FIELD BULLETIN: ND-VAL-50

NOTICE OF DISCONTINUANCE

Cyclone Valves Select Voltages

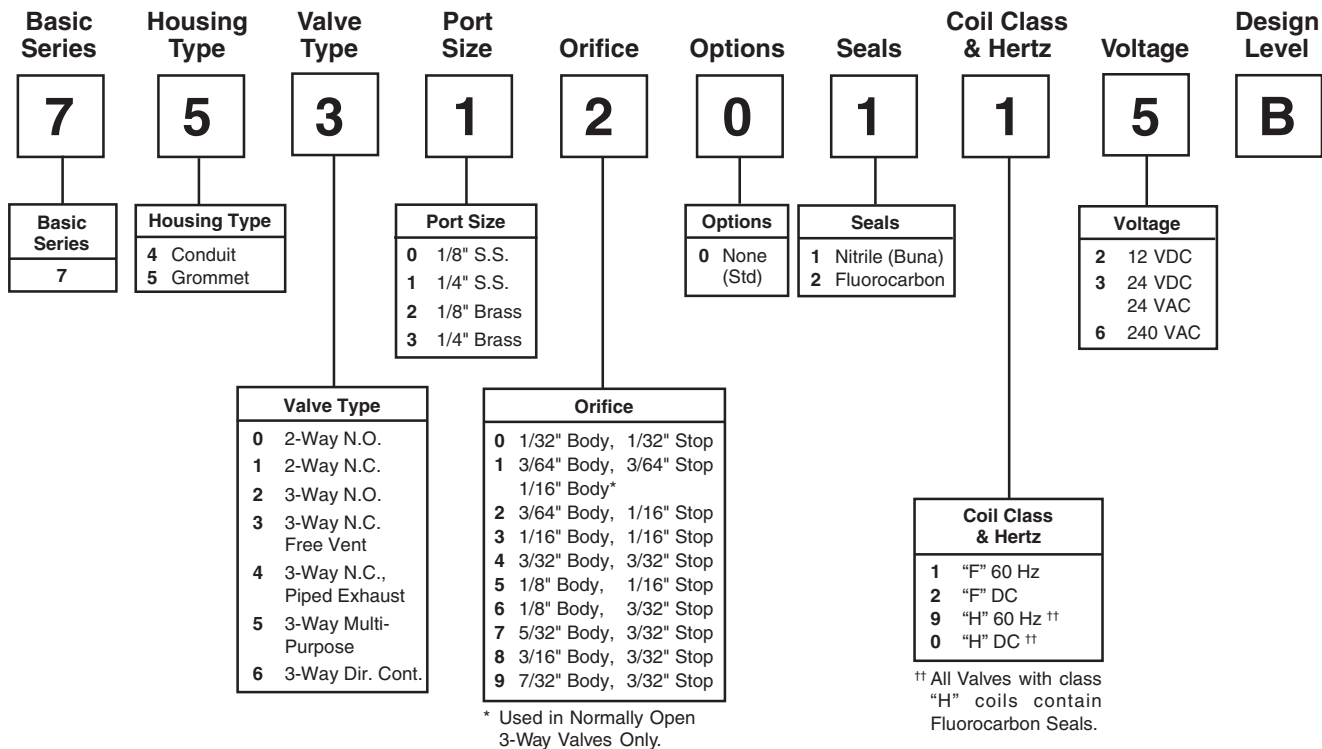
Effective immediately, PDN is discontinuing several voltages in the Cyclone Valve Series.

The following voltages will be discontinued:

<u>Voltages</u>	<u>Enclosures</u>
• 6 VDC	All
• 120 VDC	5 & 6
• 12 VAC	All
• 48 VAC	All
• 480 VAC	All

Hazardous Duty Valves (UL Approved)

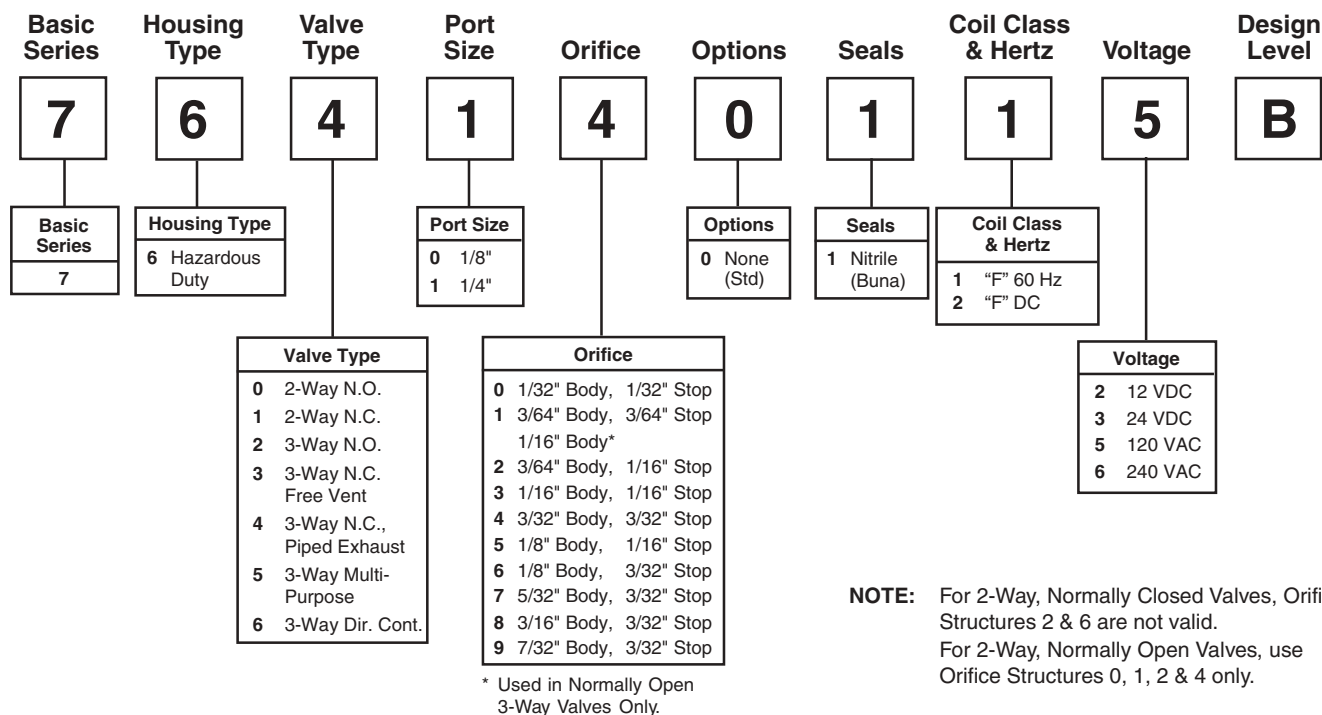
A new catalog (VAL-CYC-4) will be printed as soon as possible.
A new model index is included on back.
